STAFF REPORT
COMMUNITY DEVELOPMENT DEPARTMENT

SUBJECT: FP-2020-0002
Shelburne South No. 2

I. PROJECT DESCRIPTION

Final plat consisting of 39 buildable lots and 7 common lots on 9.52 acres of land in the R-8 zoning district.

B. Final Plat (dated: 8/18/20)

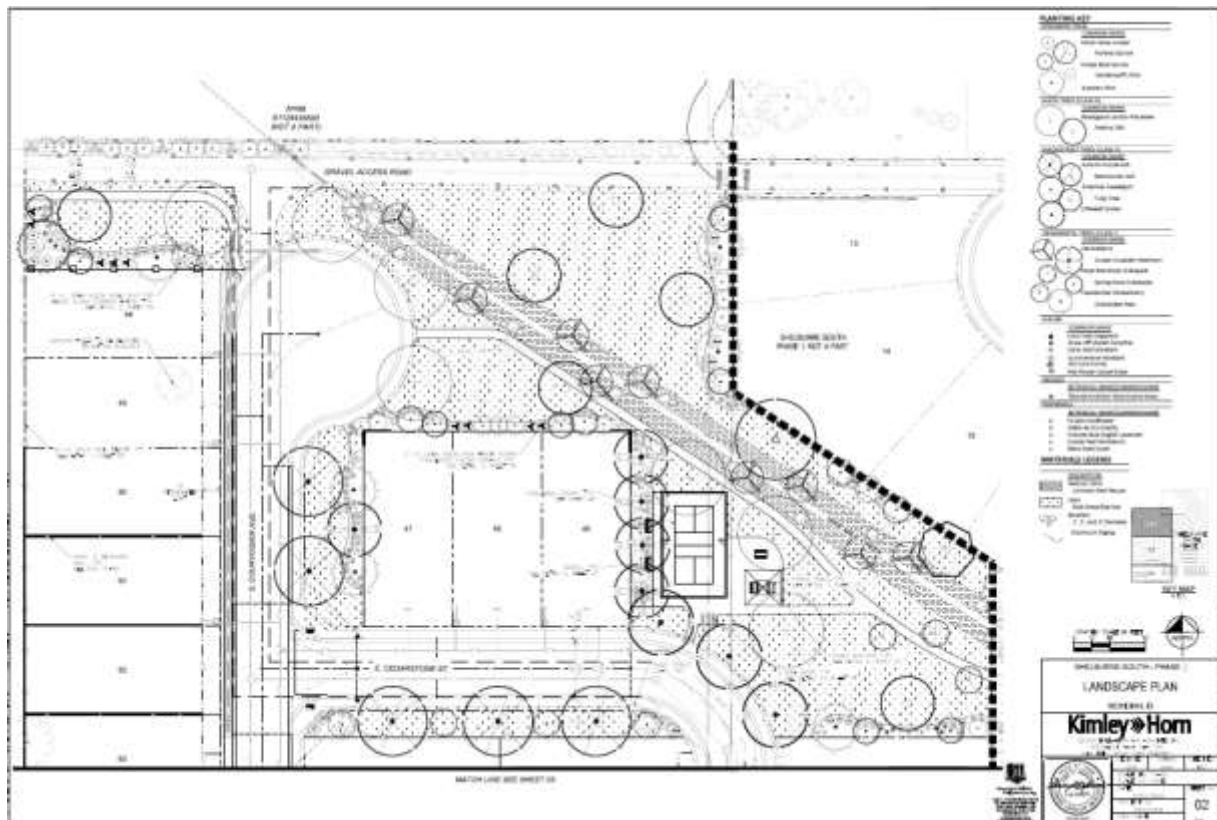
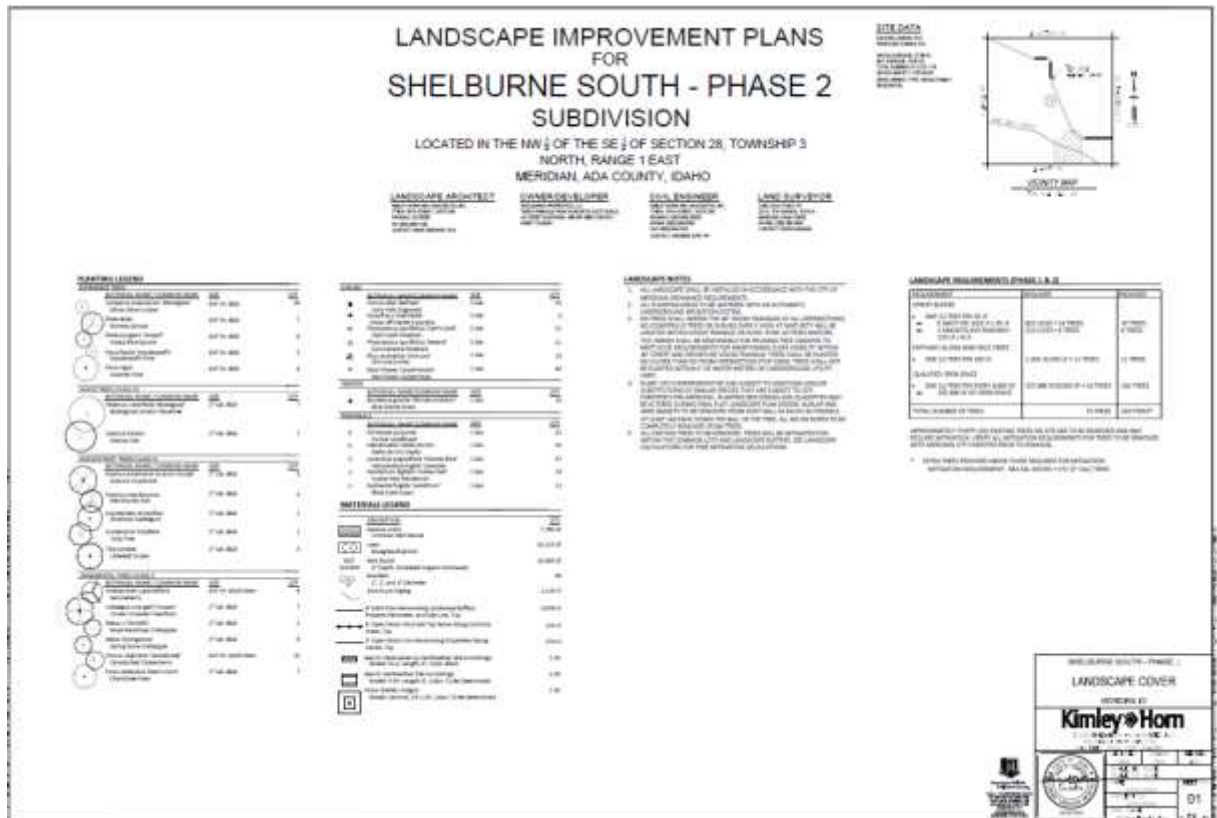
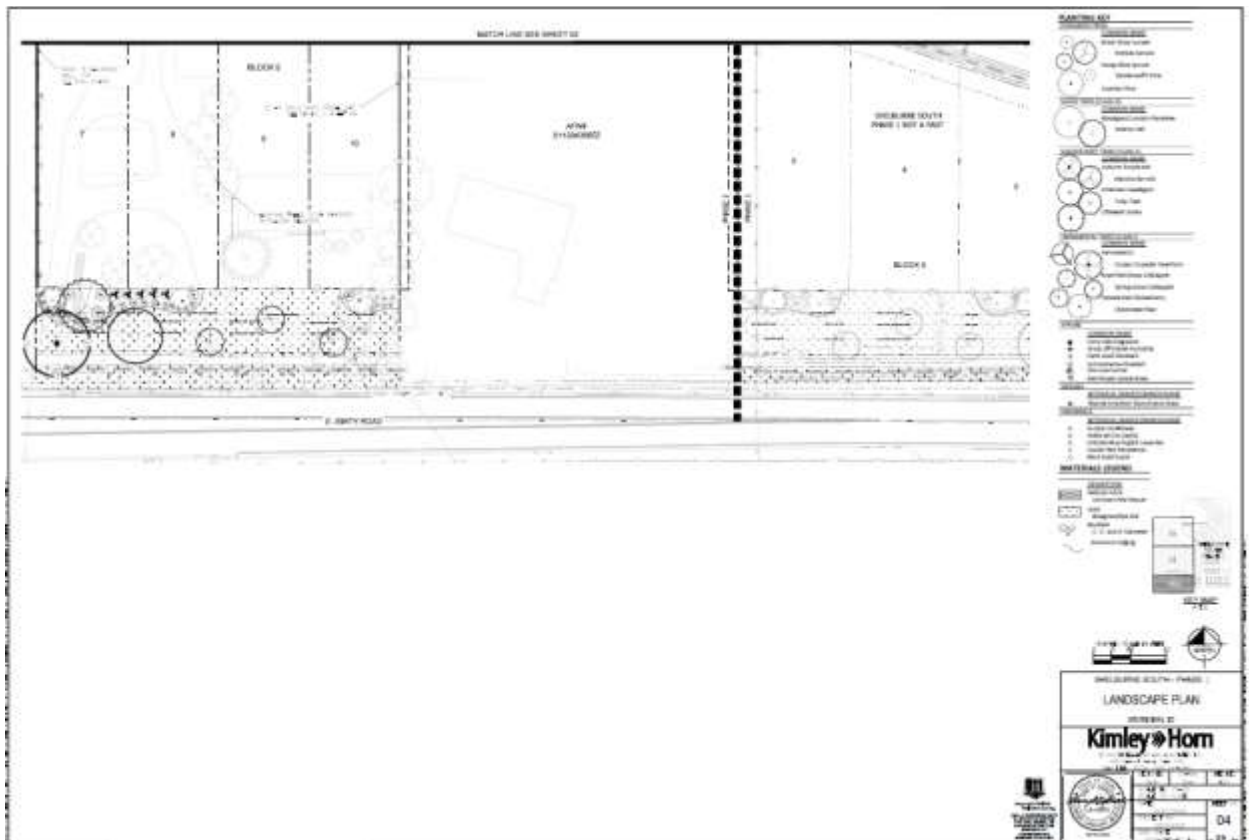
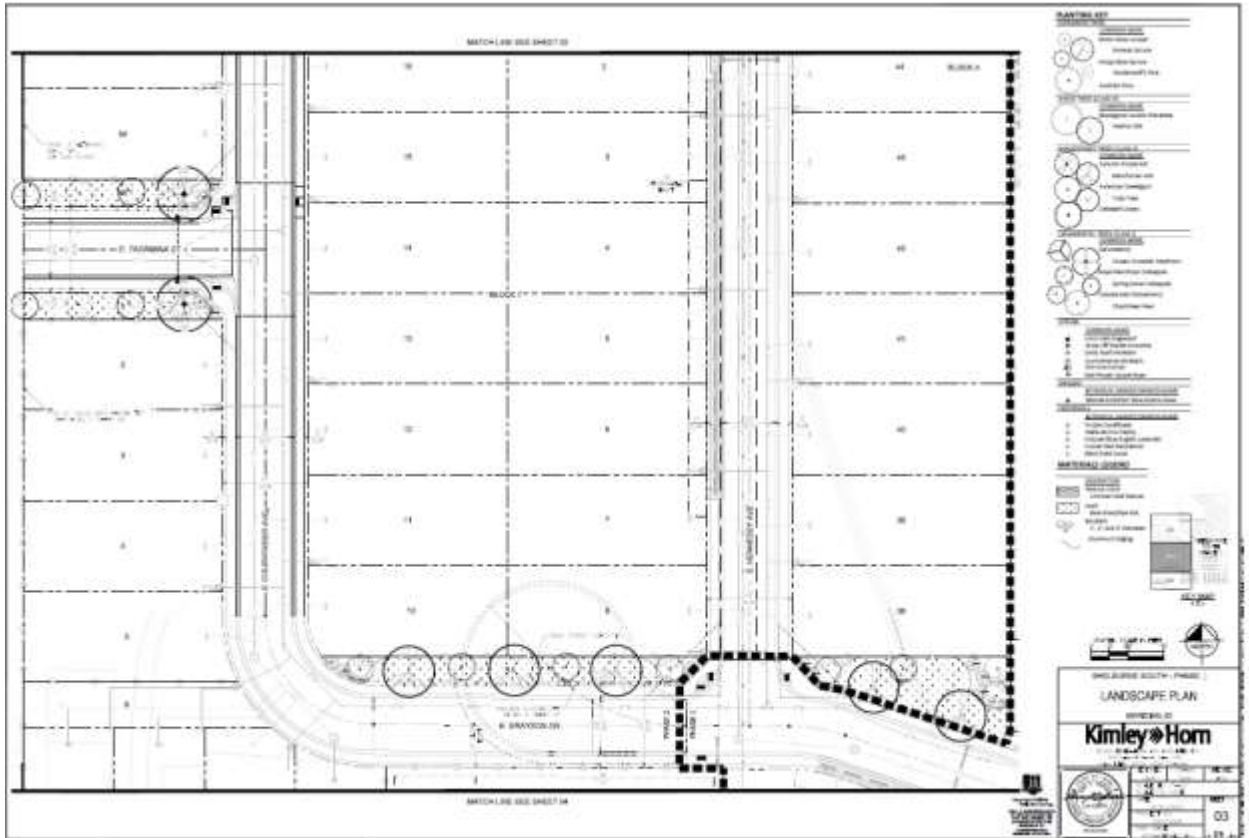
3. Prior to submittal for the City Engineer's signature, have the Certificate of Owners and the accompanying acknowledgement signed and notarized.
4. The final plat prepared by Land Solutions, stamped by Clinton W. Hansen, dated: 8/18/2020, included in Section V.B shall be revised as follows:

- a. Note #10: Include the recorded instrument number of the Development Agreement (#2020-138124).
 - b. Note #12: Include the recorded instrument number of the ACHD License Agreement.

- c. Note #13: Include the recorded instrument number of the CC&R's.
 - d. Note #15: “. . . as required by City of Meridian UDC 11-6C-3D.78. . .”
 - e. Include the recorded Book and Page number for Shelburne South Subdivision No. 1 graphically depicted on Sheet 1.

- f. Include the recorded instrument number of the existing City of Meridian sanitary sewer easement in the Legend on Sheet 1.
 - g. If the existing Idaho Power easement (Inst. 95026060) depicted on the west side of Lot 7, Block 6 is relinquished prior to the City Engineer's signature on the final plat, remove the note from the plat and submit a copy of the relinquishment letter.

A copy of the revised plat shall be submitted for City Engineer signature.

C. Landscape Plan (dated: 9/2/2020)

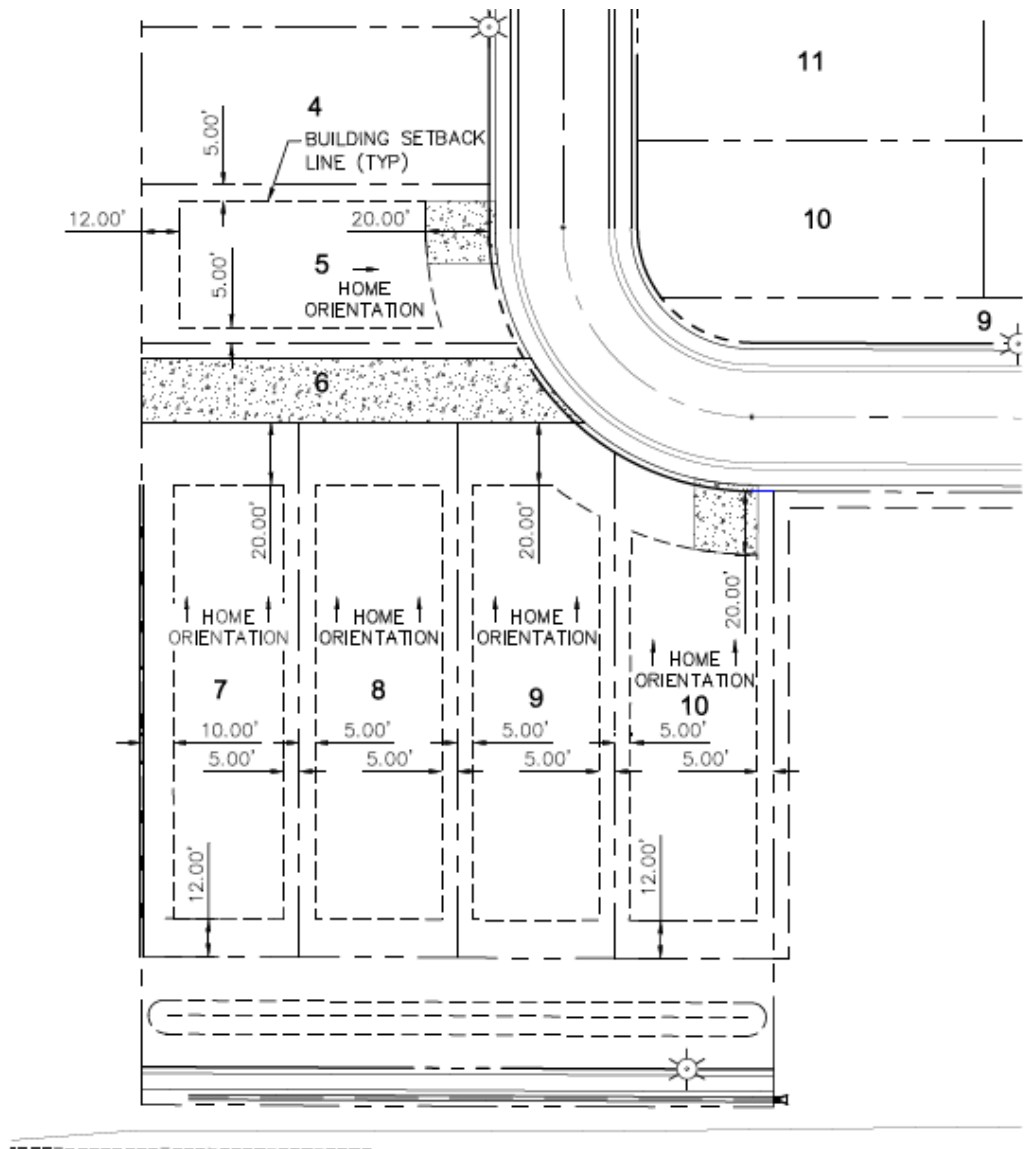
5. The landscape plan prepared by Kimley-Horn, dated 09/2/2020, included in Section V.C, shall be revised as follows:
 - a. Depict mitigation trees and calculations on the plan in accord with the standards listed in UDC 11-3B-10C.5. *Coordinate with Matt Perkins, the City Arborist, to determine mitigation requirements.*

- b. If the unimproved right-of-way of E. Amity Rd. is 10 feet or greater from the edge of pavement to edge of sidewalk or property line, the Developer is required to maintain a 10 foot compacted shoulder meeting the construction standards of ACHD and landscape the remainder with lawn or other vegetative ground cover as set forth in UDC 11-3B-7C.5. A license agreement for improvements within the right-of-way is required between the property owner and ACHD.

- c. Depict 5-foot wide landscape strips on each side of the multi-use pathway that comply with the standards listed in UDC 11-3B-12C. *A mix of trees, shrubs, lawn and/or other vegetative groundcover is required.*
